UNITED STATES PATENT AND TRADEMARK OFFICE

APPLICATION NO.	FILING DATE	FIRST NAMED INVENTOR	ATTORNEY DOCKET NO.	CONFIRMATION NO.
10/539,045	03/06/2006	Johan Ulin	12090-000016/US	7386
30/593 7590 12/08/2009 HARNESS, DICKEY & PIERCE, P.L.C. P.O. BOX 8910 RESTON, VA 20195				
EXAMINER				
WHITE, DENNIS MICHAEL				
ART UNIT		PAPER NUMBER		
1797				
MAIL DATE		DELIVERY MODE		
12/08/2009		PAPER

Office Action Summary

DETAILED ACTION

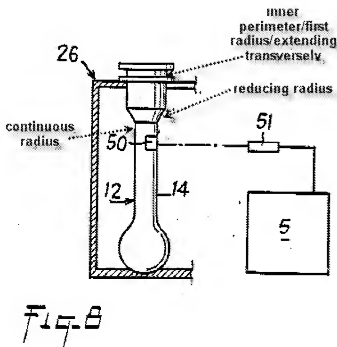
Regarding claim 16, Commarmot/Jennings teach the upper end of the two half-shells 86 ("a sleeve") is formed circumferentially for engagement with the cap, the sleeve having a first diameter portion running from the upper end to meet a reduced diameter portion in the lower end of the sleeve (see Fig. 14 above).
